NACELLE - INLET COWL - P2/T2 ROSEMOUNT PROBE, BONDING CLAMP - REPLACEMENT OF

March 31, 1992

V2500-NAC-71-0043

Removal and Replacement of the Bonding Clamp and Connector Nuts Figure 1 $\,$

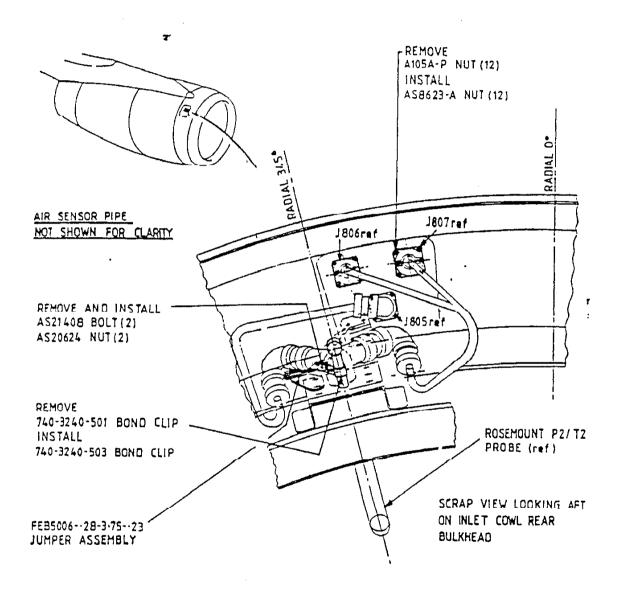
A new bonding clamp is installed for use with the 154DB Rev. D Rosemount P2/T2 probe. Additionally the nuts used to install the connector receptacles for the P2/T2 probe cable assemblies are removed and replaced with self-locking nuts.

- (1) Find the Rosemount P2/T2 probe at the top right side of the engine inlet cowl. (Refer to Figure 1.)
- (2) Remove (18) NAS8704U4 bolts which attach the probe access panel to the inlet cowl. Keep bolts and panel.

- (1) Remove the AS21408 bolt and the AS20624 nut which connect the FEB5006-.28-3.75-.23 jumper assembly to the 740-3240-501 bonding clamp.
- (2) Remove the AS21408 bolt and the AS20624 nut which attach the 740-3240-501 bonding clamp to the P2/T2 probe. Remove and discard the bonding clamp.
- (3) Install the 740-3240-503 bonding clamp to the P2/T2 probe with an AS21408 bolt and an AS20624 nut. Connect the FEB5006-.28-3.75-.23 jumper assembly to the new bonding clamp with an AS21408 bolt and an AS20624 nut. Torque the two bolts to 40 lb-in. (4.5 N.m).
- (4) Find the J805, J806, and J807 connector receptacles on the inlet cowl bulkhead. Remove and discard the (12) Al05-A-P nuts that hold the receptacles to the bulkhead.
- (5) Install (12) AS8623-A self-locking nuts to hold the J805, J806, and J807 connector receptacles to the bulkhead.
